# Development Assessment Panel of City of Prospect

5.1 67 Prospect Road, Prospect - Change of Use to Childcare Centre with associated Car Parking, Landscaping and Fencing (DA 050/61/2017)

5.2 14 Flora Terrace, Prospect - Removal of a Significant Tree (Norfolk Island Pine) (DA 050/54/2017)

**Proposal:** Change of Use to Childcare Centre with associated Car Parking, Landscaping and Fencing (DA 050/61/2017)

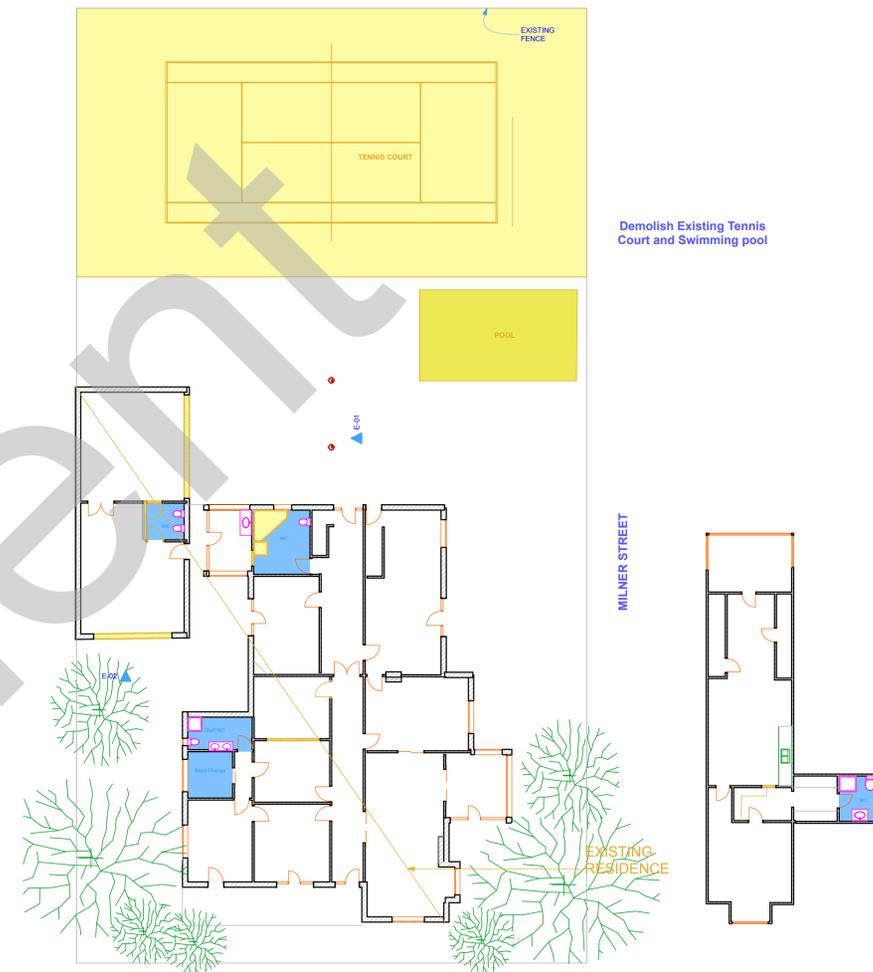
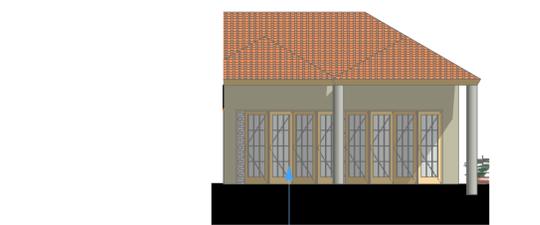
We refer to the above development as shown in Drawing A.01.1 Revision A. In forming our opinions on the matter, we have inspected the subject site and observed traffic and parking conditions during the morning and afternoon peak periods. We have also reviewed the reports by GTA and Masterplan consultants.

While the Council's Development Plan does not specify a bicycle parking rate for a child care centre, we recommend that 2 bicycle parking rails be provided near the entrances to the building to encourage cycling as a mode of transport for staff and parents.

1. Relocate the disabled parking closer to the Milner Street frontage. The first space should be the clear zone space with the second space being the disabled parking space.
2. From the clear zone space (can be used as a path access), provide a security gate into the play area (relocate the vegetable garden to suit) with a footpath linking the car park to the entrance of the building.

The proposal plan shows that all of the rooms on the ground floor are 'teaching spaces'. It is unclear where the main reception area is where parents have to sign in or sign out during drop off and pick up times.

The proposed bin enclosure is not identified in the proposal plan. We recommend that this bin enclosure be located next to the car park to assist in collection by the private contractor.

- The building is existing on the site and has been drawn to scale on the site plan, confirming the building's distance from the allotment boundaries.
- The car park layout has been amended with the inclusion of a disabled car parking space and clarification of the car park dimensions.

- The play areas have been indicated on the site plan. One large play area is proposed to surround the building, contained by a 1.8 metre high masonry fence on the external boundary and a 1.8 metre high Colorbond fence adjacent to the car park. Notably, the entrance to the play area and facility is via a dual gate system with a 1.5 metre high security fence.

The car park has been substantially amended including the first car parking space being setback from Milner Street and the relocation of the disabled car parking space. The clearer site plan and site arrangement are considered to represent safe and convenient access to and from the site.

*Crack to the southern wall western side of the front bedroom*

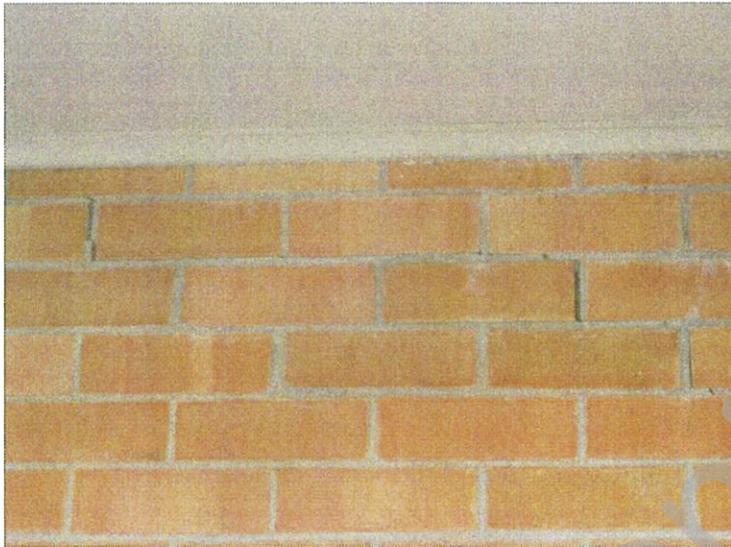
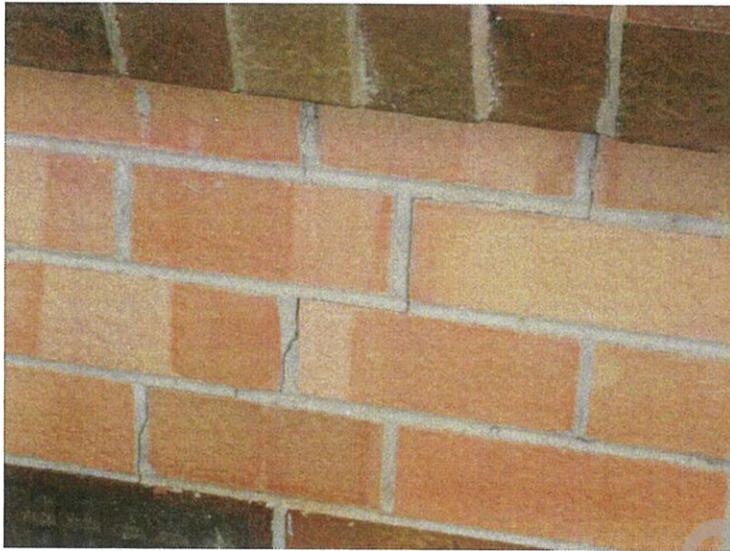
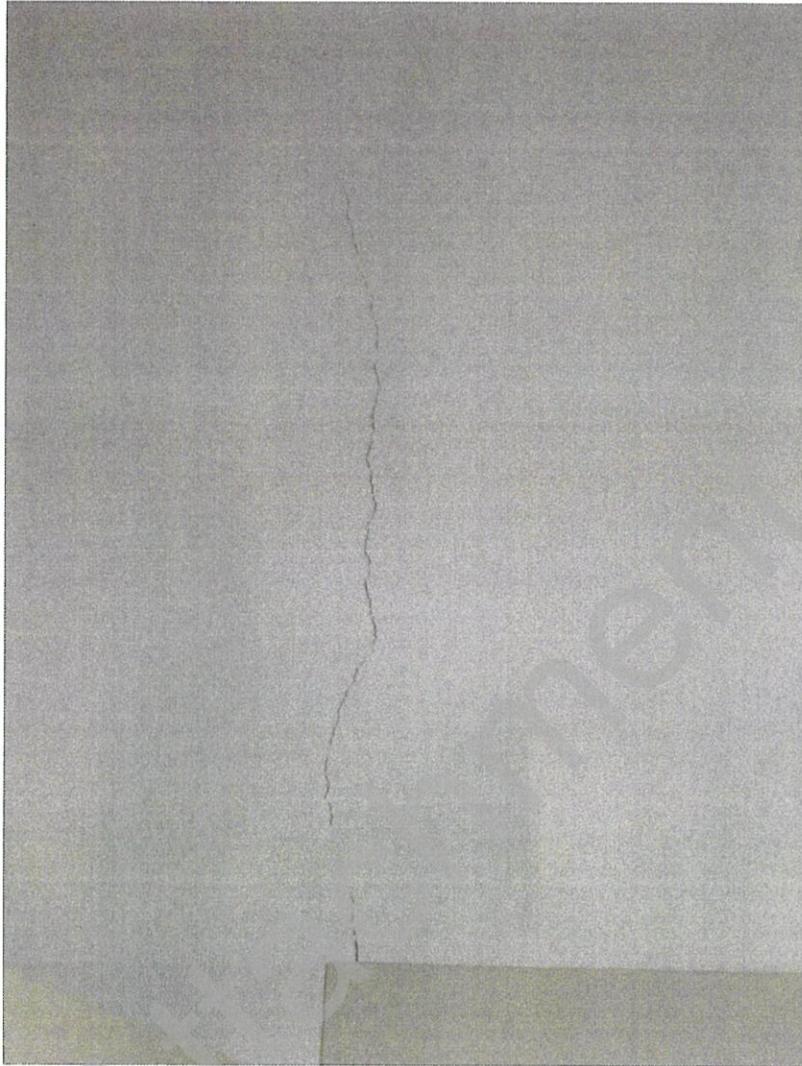
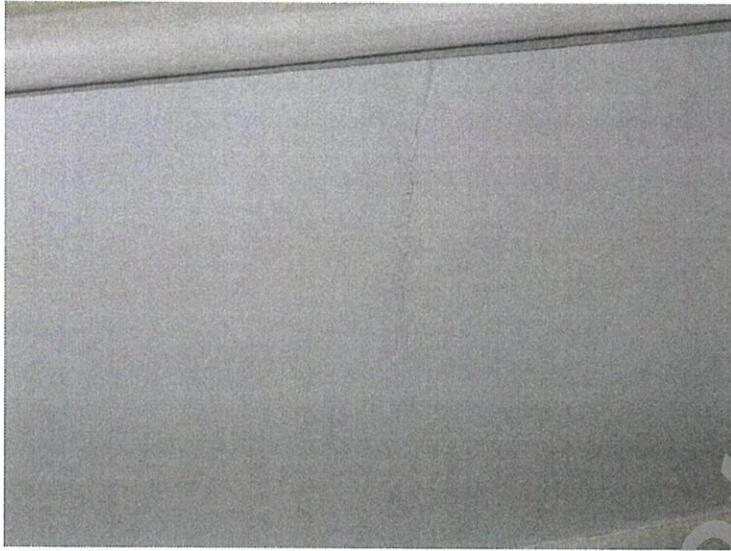
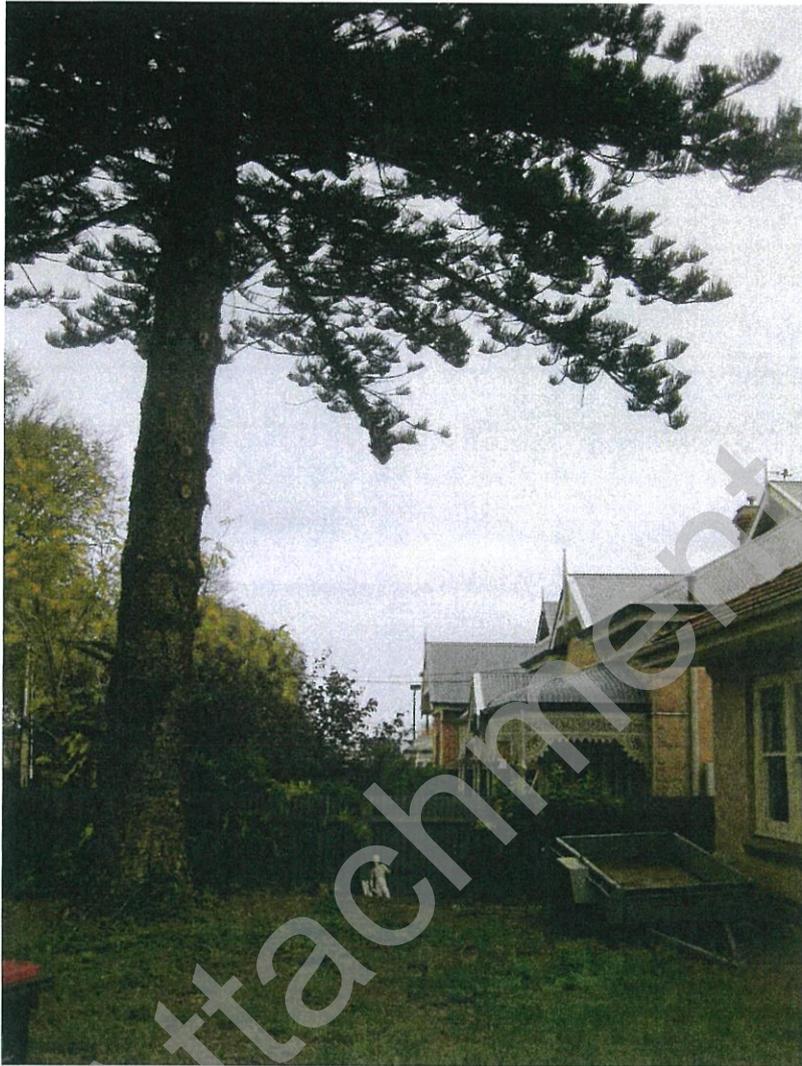
A root barrier could possibly be installed to further restrict the influence of the tree's roots on the dwelling.

That the tree in the front yard of 14 Flora Terrace Prospect not be removed at this time.

Figure 1 Subject tree, viewed from the north-east.

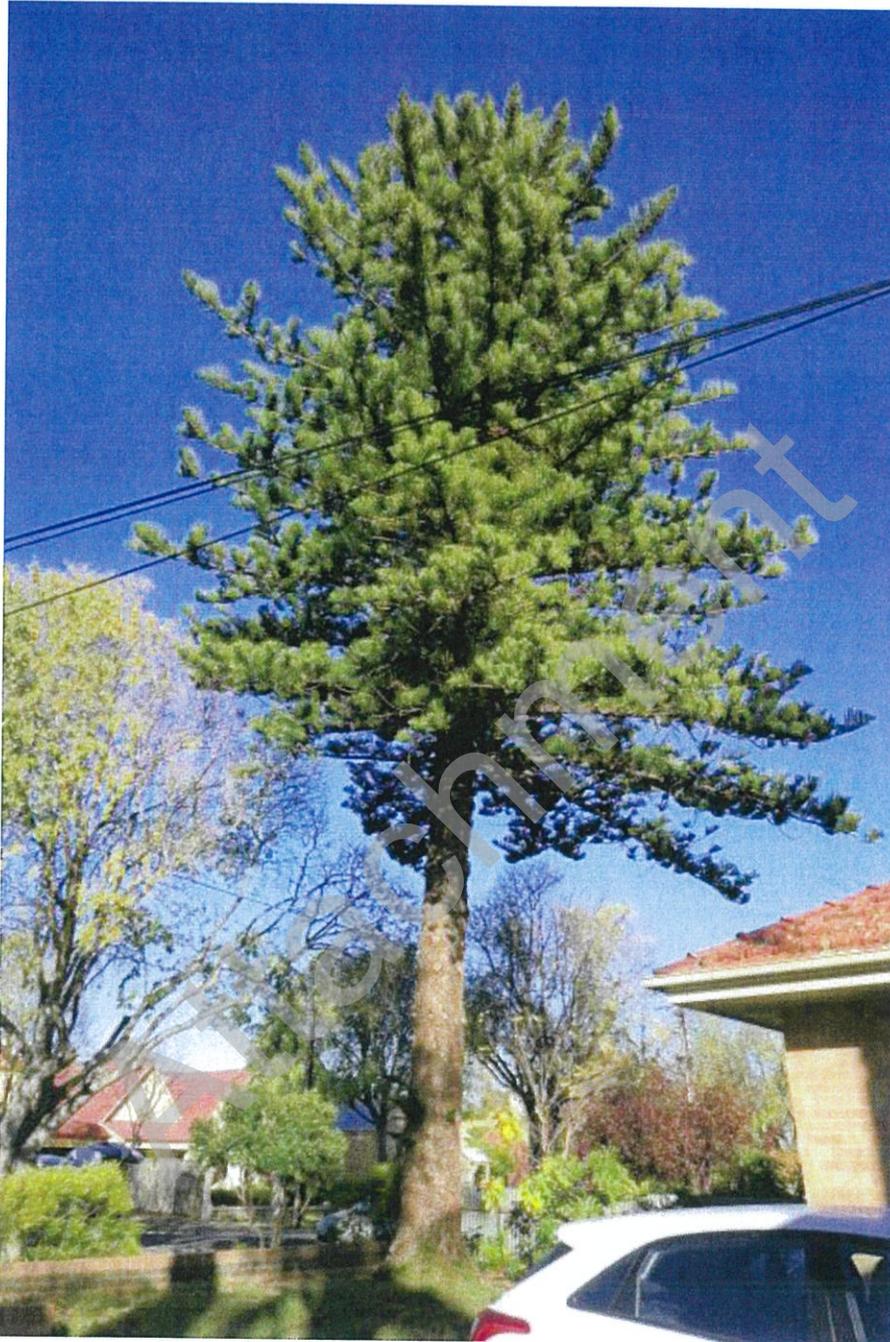
The tree is located in the front yard (refer Figure 1). The trunk centre is 2.6 metres from the southern boundary fence, 3.7 metres from the western boundary fence and 5.6 metres from existing house.

Figure 1 Palm One, viewed from the north-east.

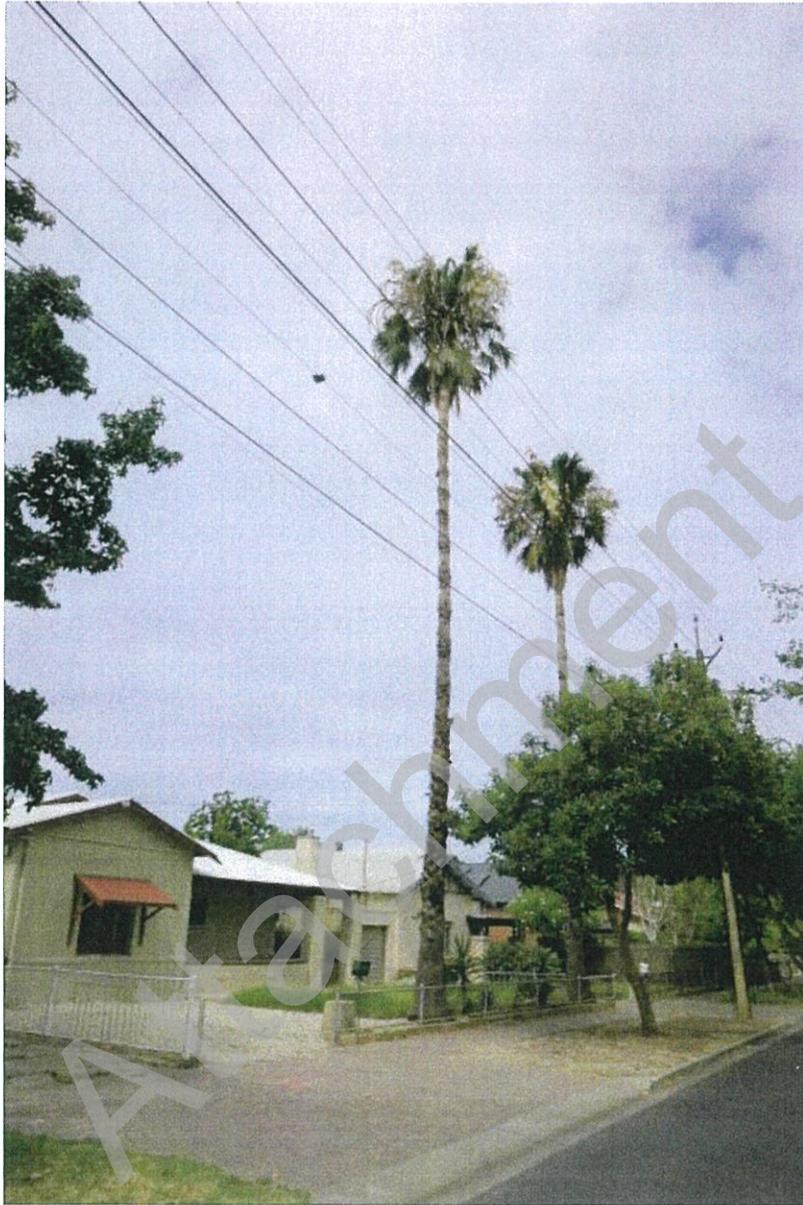
Palm One is the eastern most palm (refer Figure 1). The trunk centre is 7.2 metres from the nearest dwelling and adjacent to the front fence.

Figure 1 Tree One, viewed from the north-east.

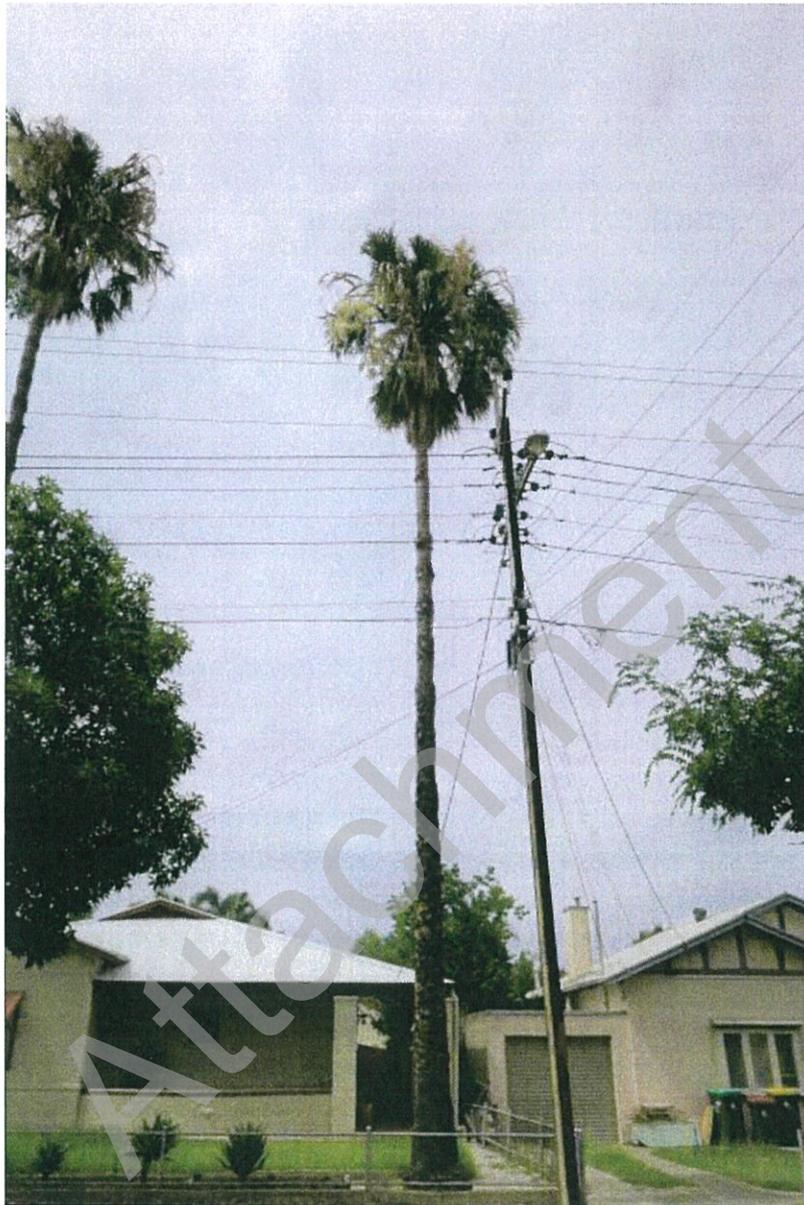
Palm Two is the western most palm (refer Figure 1). The trunk centre is 7.3 metres from the nearest dwelling and adjacent to the front fence.
